**Ambulance Service
of New South Wales**

SUBMISSION 2

Re: Villawood Immigration Detention Centre Redevelopment, Sydney

FIRST PREFERENCE
 Drive through "Porte Cochere"
 access to hospital ambulance entry.

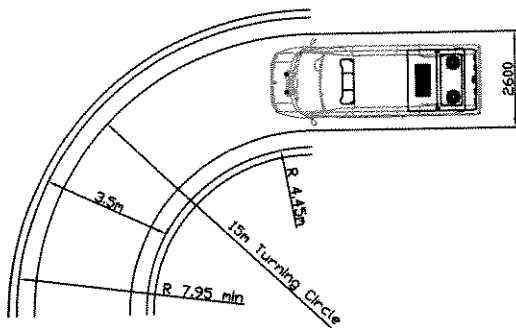
The Ambulance Service of New South Wales requests that the area designated for ambulance patient collection or delivery be designed in accordance with ambulance service guidelines, copies of which are attached.

Turning circles and clearances to kerbs, existing buildings or other obstructions are for the current largest size of ambulance vehicle which requires a minimum turning circle of 15 metres.

The canopy over the entrance is to be large enough to provide ample cover for two officers to unload the patient from the rear of the vehicle.

The surface beneath the canopy should be level and non-slip and ideally at the same level as the entrance to the building. Canopies must be clear of the vehicle turning circles and the stretcher handling area.

The height of the canopy from finished paved area to the underside should be 3.5 metres (3.2 metres to the underside of any beam).
